**World Forum for Harmonization of Vehicle Regulations****Working Party on Noise****Fifty-sixth session**

**Collective amendments—Regulation Nos. 9 and 63****Proposal for the 02 series of amendments to Regulation No. 63 (Uniform provisions concerning the approval of two-wheeled mopeds with regard to noise)****Submitted by the experts of the International Motorcycle Manufacturers Association \***

## Regulation No. 63

### Uniform provisions concerning the approval of two-wheeled mopeds with regard to noise

Table 1  
**Correction applied to individual measured test value**

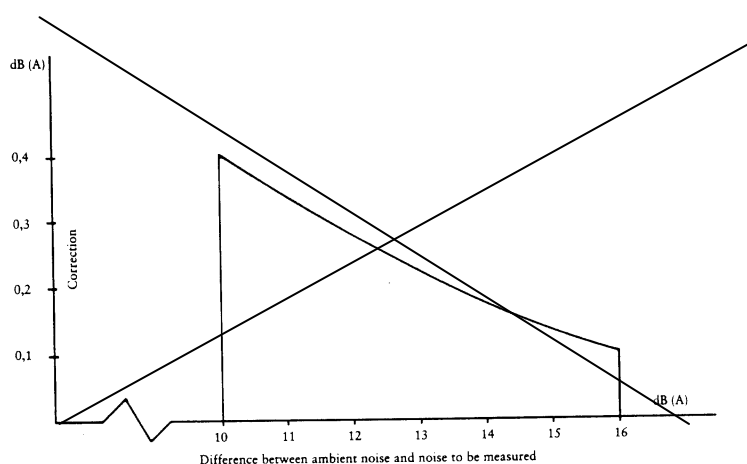
If the difference between ambient and measured noise-levels is between 10 and 16 dB(A), the appropriate figure shall be subtracted from the value recorded by the sound-level metre, in accordance with the following graph: 15 dB(A), in order to calculate the test result the appropriate correction shall be subtracted from the readings on the sound level meter, **as given in Table 1.**

Background sound pressure level difference to measured sound pressure level, in dB	10	11	12	13	14	≥ 15
Correction, in dB(A)	0.5	0.4	0.3	0.2	0.1	0.0

Fig-1

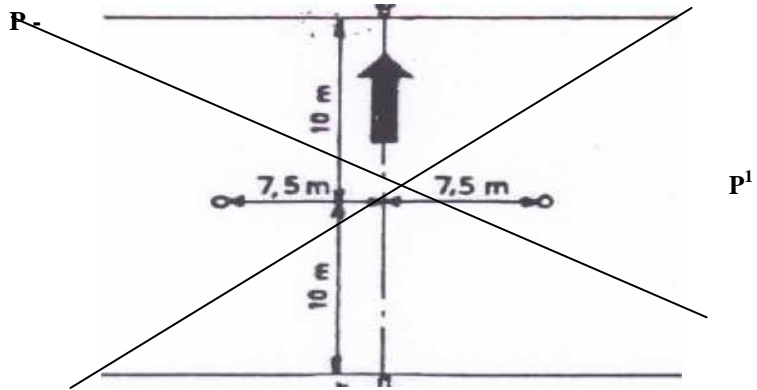
**The distance of the microphone positions from the line CC', on the microphone line PP', perpendicular to the reference line CC' on the test track (see appendix, figure 1), shall be 7.5 ± 0.05 m.**

**The microphones shall be located 1.2 ± 0.02 m above the ground level. The reference direction for free-field conditions (see IEC 61672-1:2002) shall be horizontal and directed perpendicularly towards the path of the moped line CC'.**
    - 3.1.1.3. Two lines, AA' and BB', parallel to the microphone line PP' and situated respectively 10 m forward and 10 m rearward of that line shall be marked out on the test track. The moped shall approach line AA' at an initial steady speed as specified below. When the front of the moped reaches line AA' the throttle shall be fully opened as quickly as practically possible and kept in

Figure 4.  
Reference point

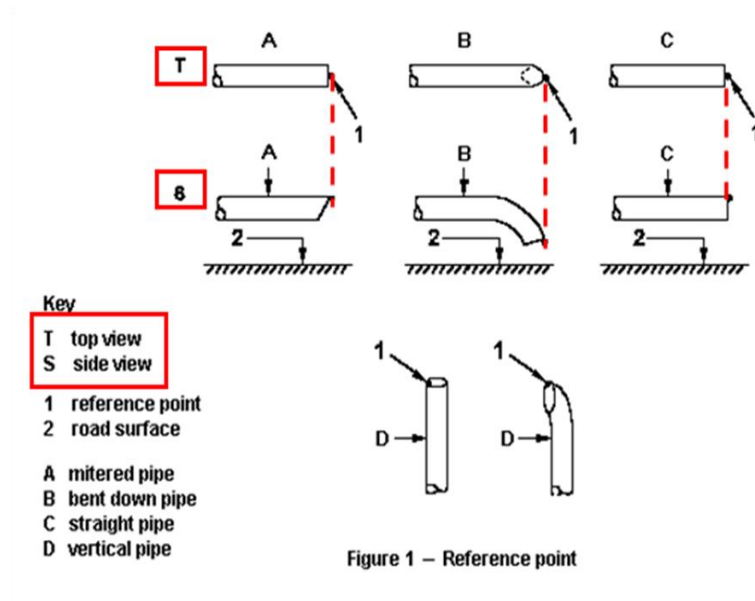
**The microphone shall be located at a distance of  $0.5 \pm 0.01$  m from the reference point of the exhaust pipe defined in Figure 4 and at an angle of  $45 \pm 5^\circ$  to the vertical plane containing the flow axis of the pipe termination. The microphone shall be at the height of the reference point, but not less than 0.2 m from the ground surface. The reference axis of the microphone shall lie in a plane parallel to the ground surface and shall be directed towards the reference point on the exhaust outlet.**

The reference point shall be the highest point satisfying the following conditions:

- (a) The reference point shall be at the end of the exhaust pipe,
- (b) The reference point shall be on the vertical plane containing the exhaust outlet centre and the flow axis of the exhaust pipe termination.
